PLANT NAME: TURKEY POINT UNITS 3 & 4
ST. LUCIE UNIT # 1

December 14, 1977
L-77-380

Re: Florida Power & Light Company
Docket Nos. 50-250, 50-251, and 50-335
Request for Information

FLORIDA POWER & LIGHT COMPANY
DOCKET NOS. 50-250, 50-251, & 50-335
NRC REQUEST FOR INFORMATION
SYSTEM DISTURBANCE (5/16/77)

MYERS NO. 1
V_{A-N}
" V_{B-N}
" V_{C-N}
" I_A
Fault
" I_B
" I_C
" I_{CAR}
" $3I_0$
NOT USED
"
"
GROUP 3
RINGLING SUBSTATION
10:24 AM
5/16/77

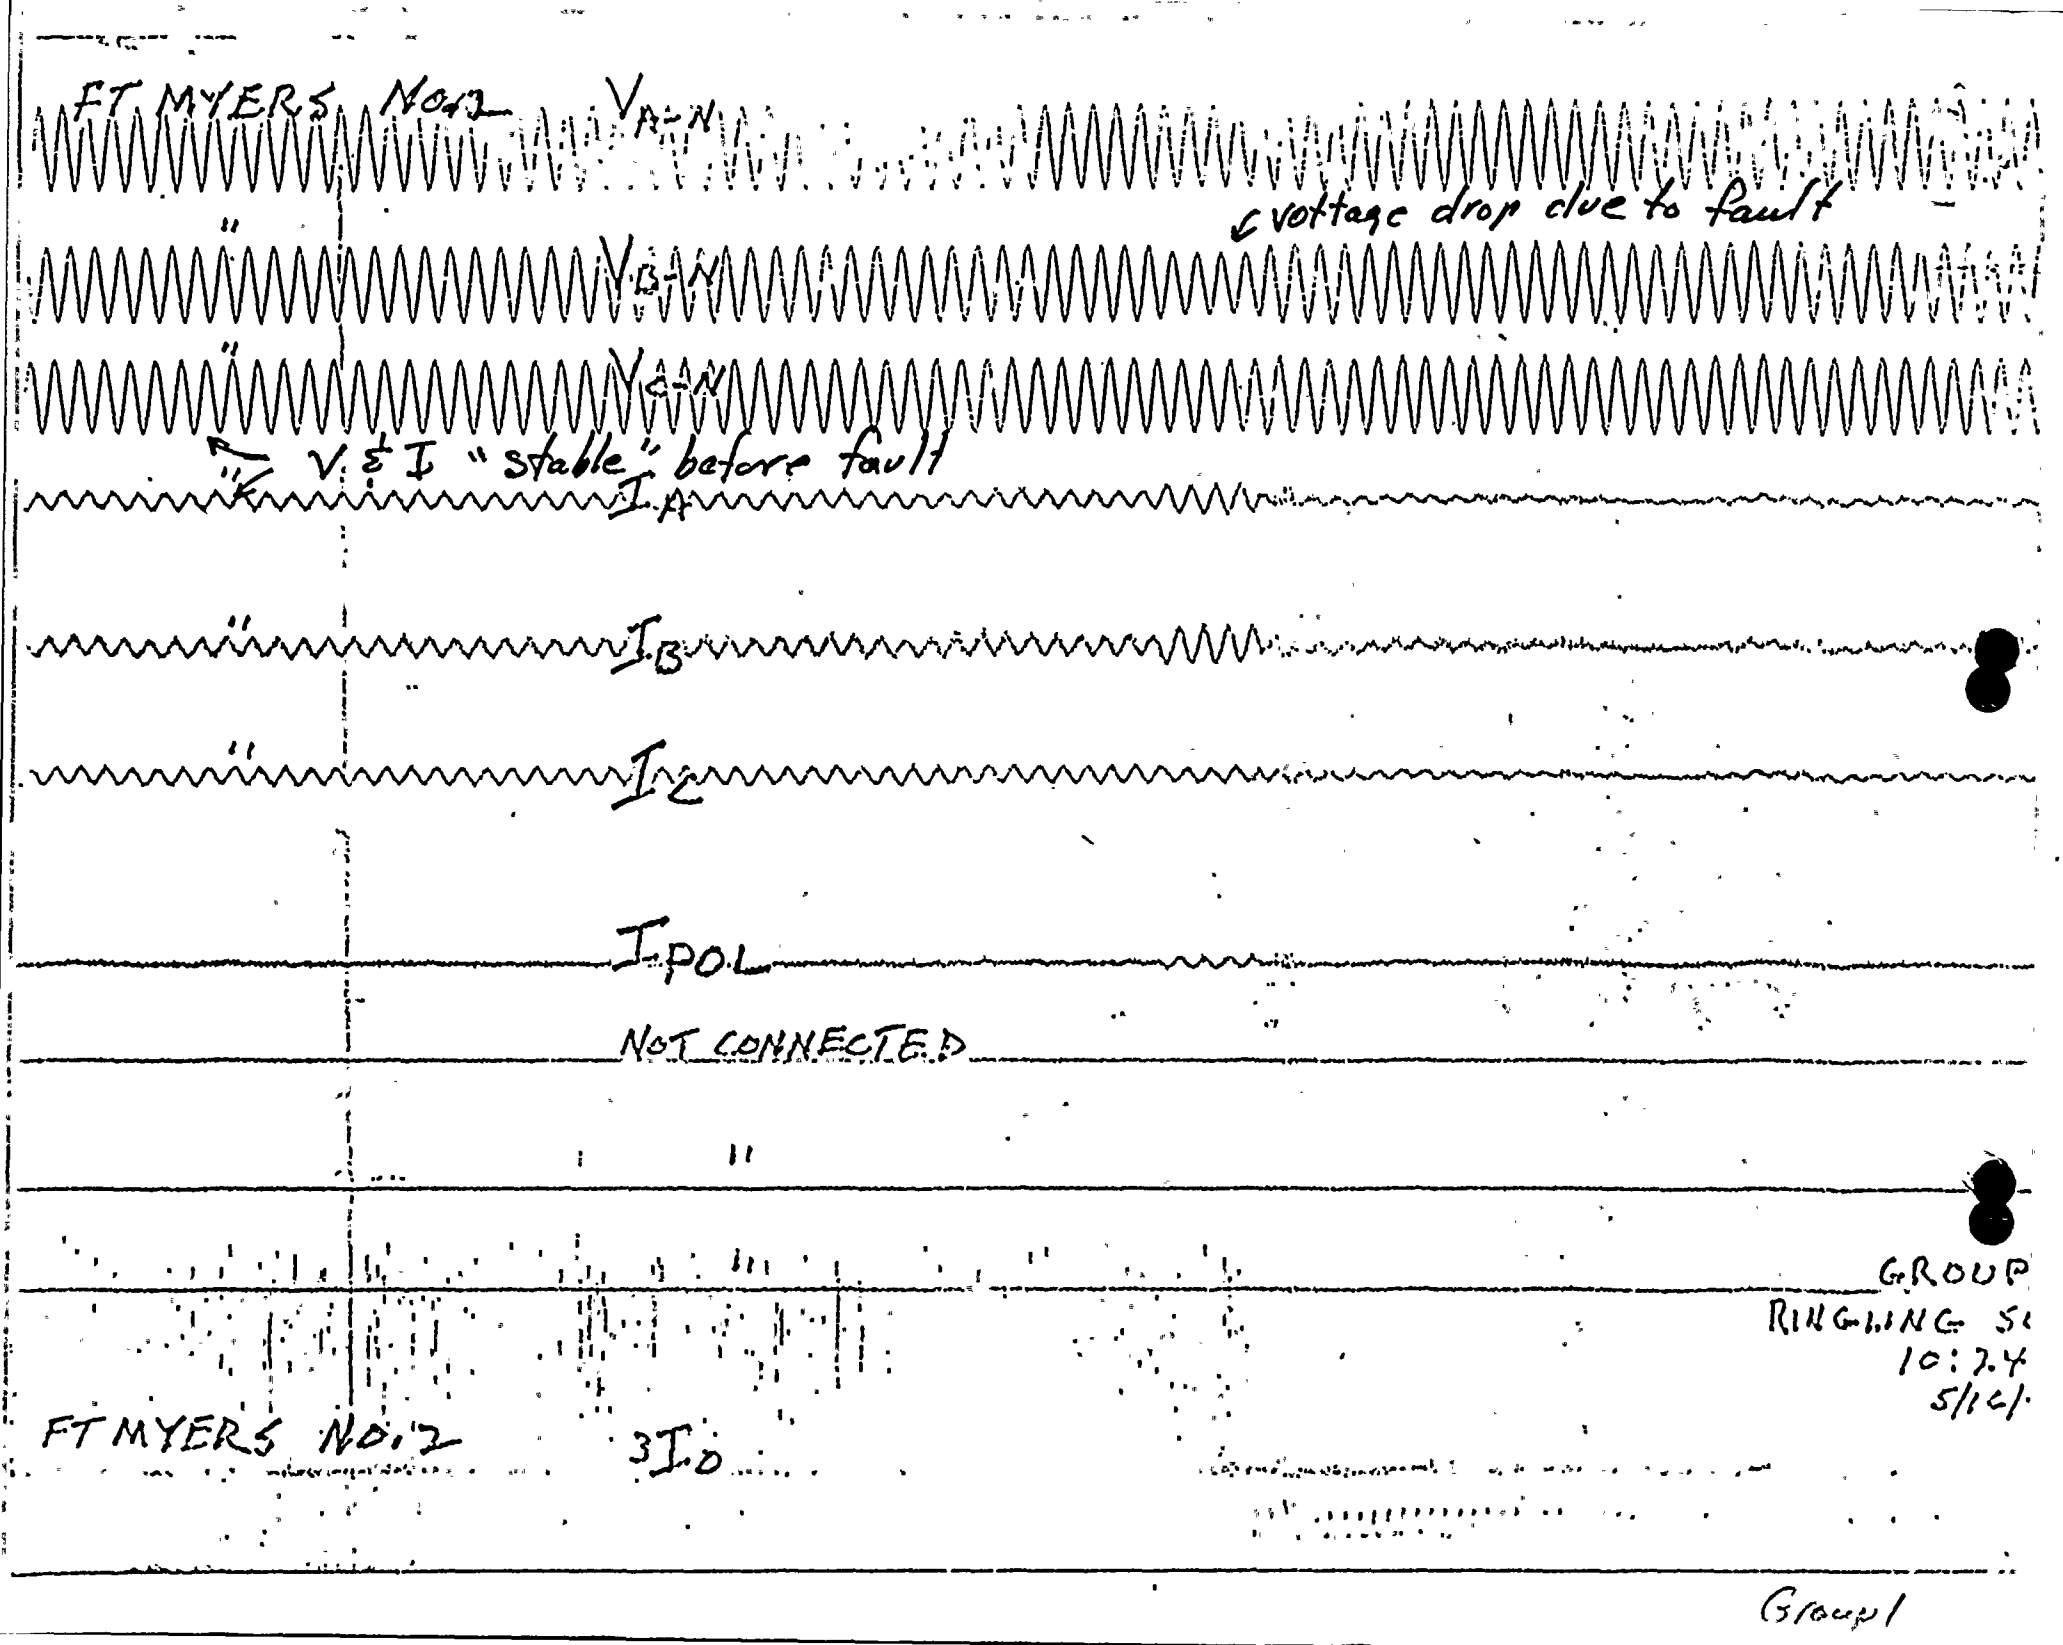
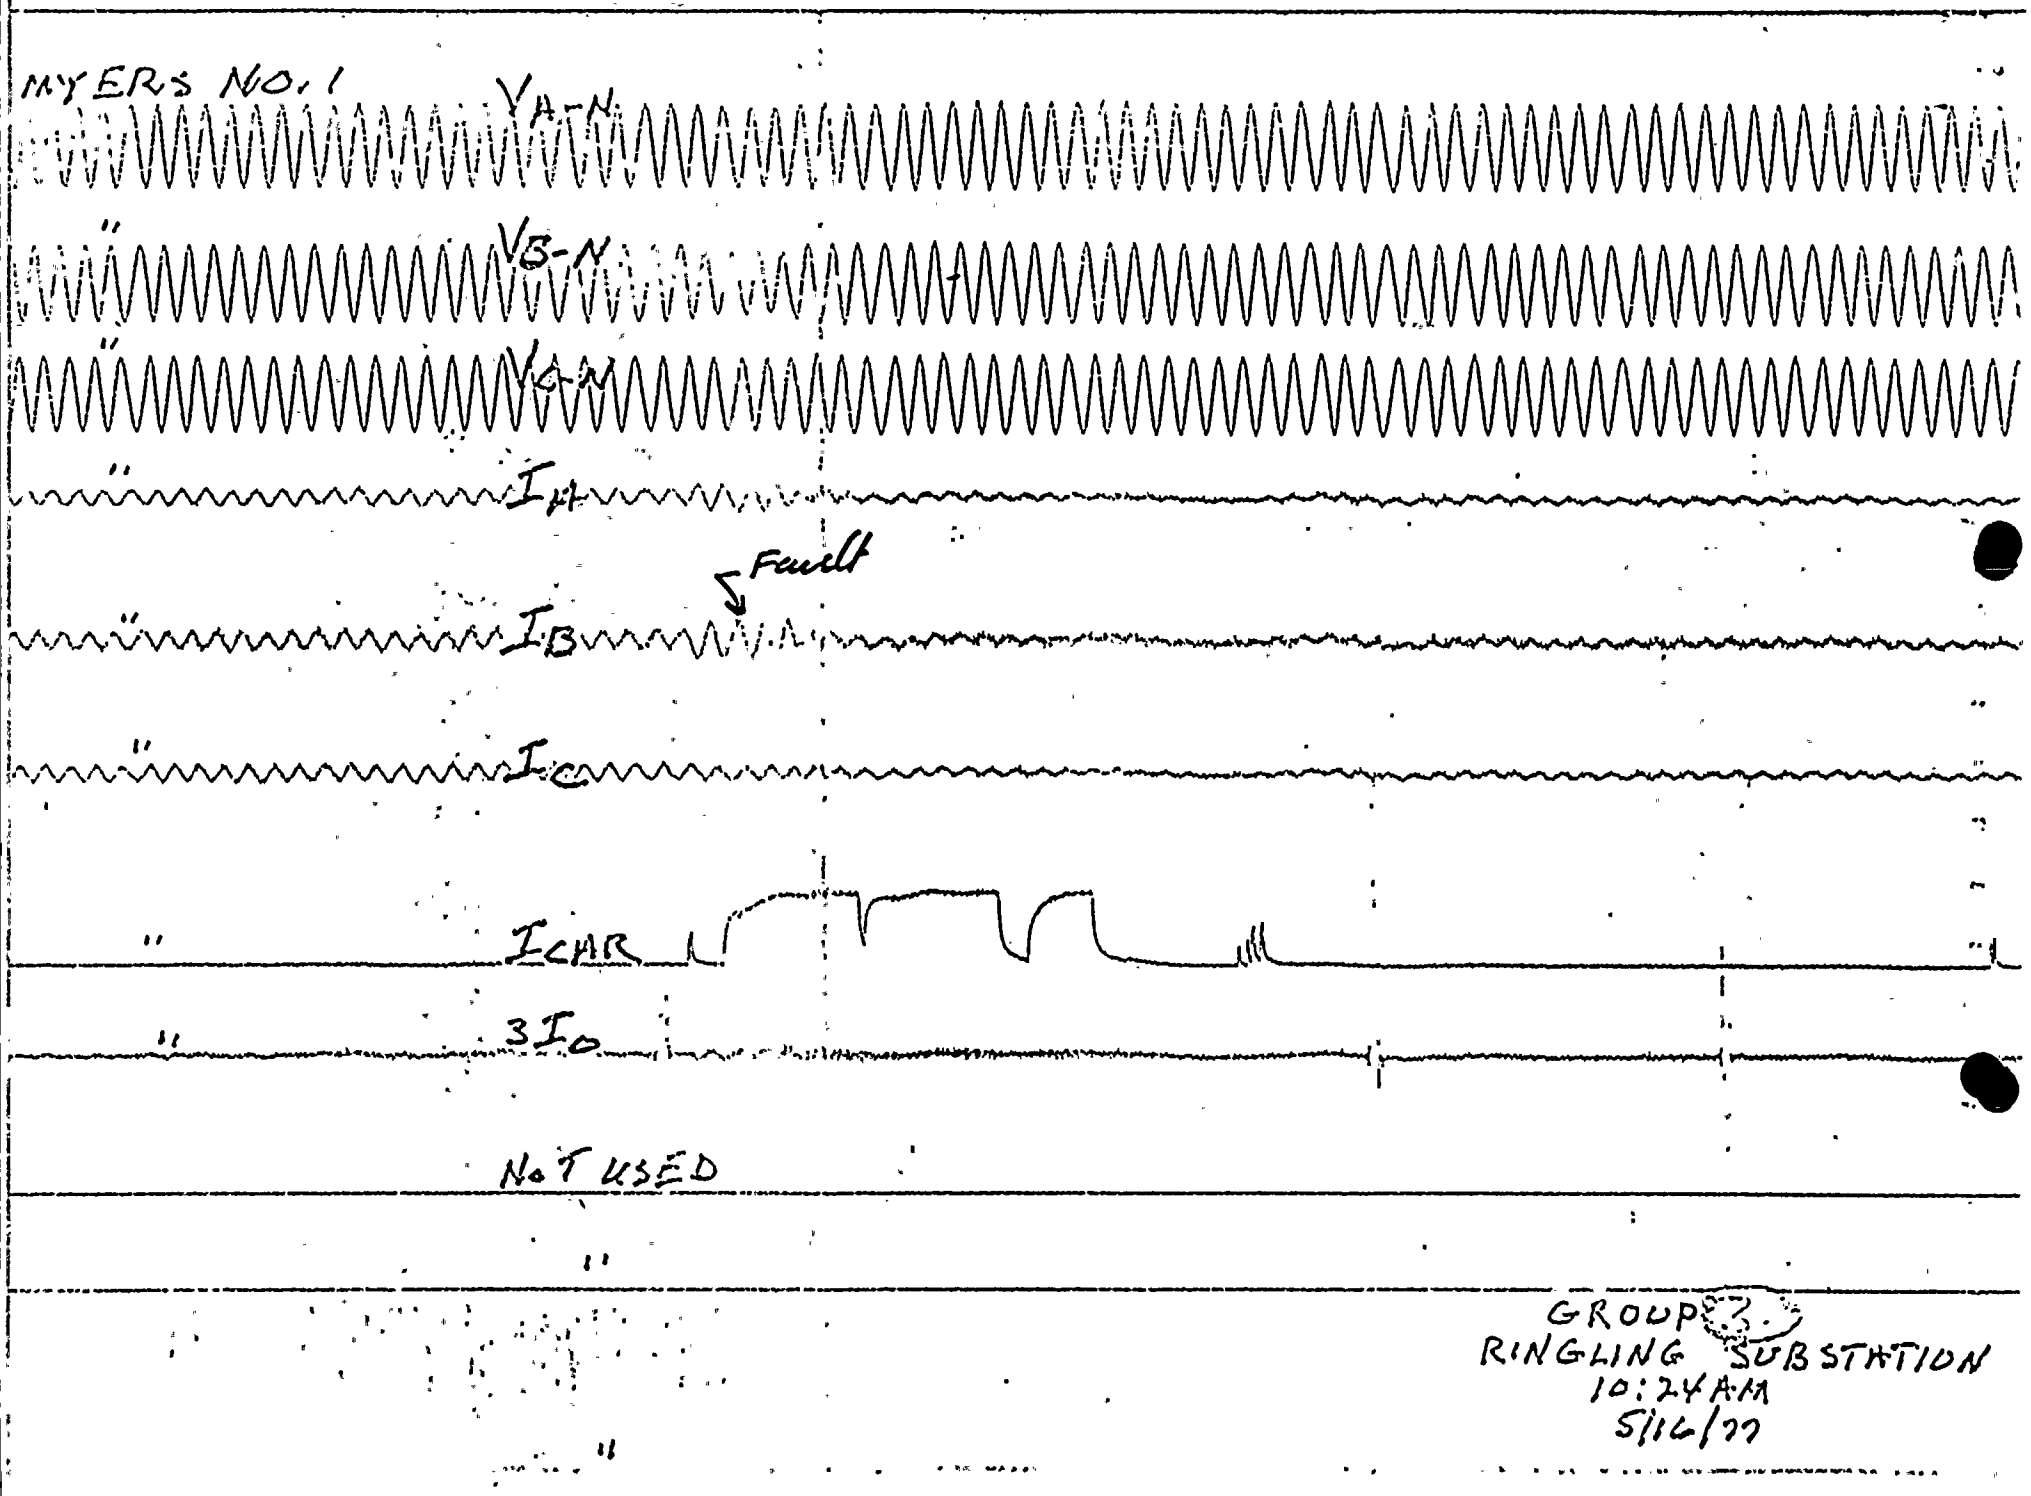
So that we may better understand the causal relationships between the events that occurred on May 16, 1977, please provide the following information:

1.7 The line loading information (power, power factor, etc.) on this line for each occasion in the past when it relayed open.

The Fort Myers-Ranch line tripped at both ends with a ground pilot target at Ranch and a Zone 1 and ground instantaneous targets at Fort Myers. Broward, Midway and Ringling oscillographs recorded a phase-to-ground fault at this time. The Ringling oscillogram indicated a "B" phase-to-ground fault.

The attached oscillogram from Ringling shows a discrete step

change in current, indicating a fault rather than an over-current. The oscillograph is a 32 channel machine, but due to play back limitations, the output is printed on three separate pages.
